Correction: Design and characterization of a plasmonic Doppler grating for azimuthal angle-resolved surface plasmon resonances

DOI: 10.1039/d0nr90260h

Correction for 'Design and characterization of a plasmonic Doppler grating for azimuthal angle-resolved surface plasmon resonances' by Kel-Meng See *et al.*, *Nanoscale*, 2017, **9**, 10811–10819, DOI: 10.1039/C7NR01509G.

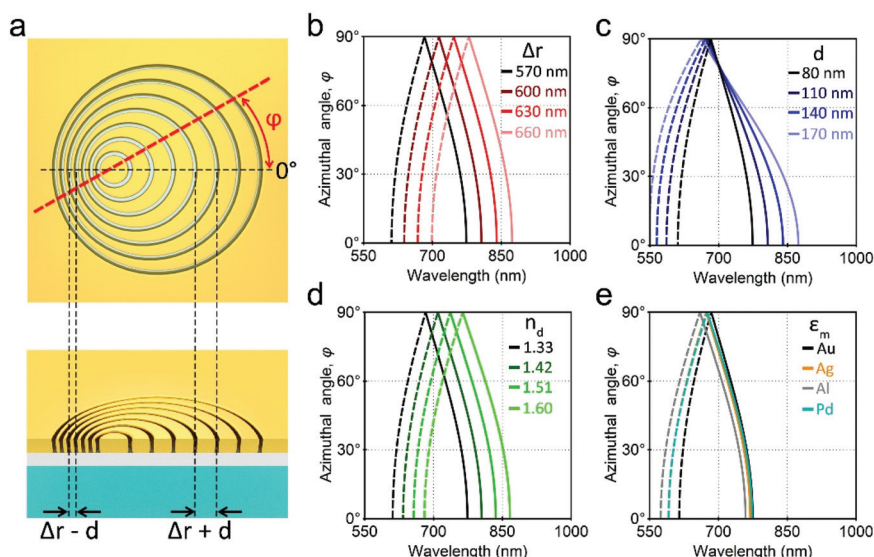
The authors regret that Fig. 1e of the original paper contained an error in the curves displayed for the silver, aluminium and palladium gratings. Specifically, a different value of the 'index of the environment' (1.65) was used in the calculation of these curves compared to that used for calculating the optical response of the gold grating (1.33). The correct Fig. 1 below, displays the curves calculated with the same value of the index of the environment (1.33). No amendments are made to the caption of Fig. 1 or the other sub-figures presented in the figure. This error does not affect any of the results or conclusions reported in the paper; only the display of the figure.
